Re: The Downs Site Development
Commentary on Dan Burden's Walkability and City Mobility Suggestions

Re: The Downs - Preliminary Site Plan Review for Engineering
OHM Job No. 0152-21-1020

Re: The Downs Site Development, City of Northville
Traffic Impact Study Review

Road Right of Way (ROW)

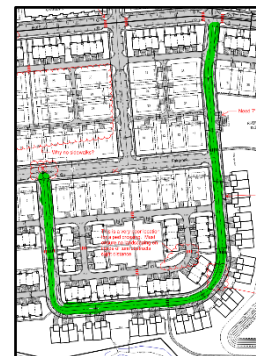
We are relatively sanguine regarding ROW widths, so long as the proposed width can accommodate public interests in these corridors of land. That includes proposed overhead and underground utilities (electric, gas, water, sanitary sewer, storm sewer, telecom, cable TV, fiber optic lines, etc.) and their above ground manifestations (junction boxes, fire hydrants, utility poles, etc.), clear pedestrian paths meeting ADA requirements, and vehicle needs of travel and parking lanes. For most communities in Southeast Michigan, 60' wide ROW for local roads is considered the norm for a local street with only two travel lanes, one in each direction. OHM recommends that streets be configured with a minimum 60' ROW.

Regarding these considerations, the Dan Burden recommendation for 90-degree parking on Cady St and Beal St calls into question if the existing 50' ROW on Cady or planned 60' ROW on Beal is adequate. By our calculations, at least 70' minimum is required, or 80' if dedicated on-street bike lanes are desired. The topic of angle parking will be further discussed below.
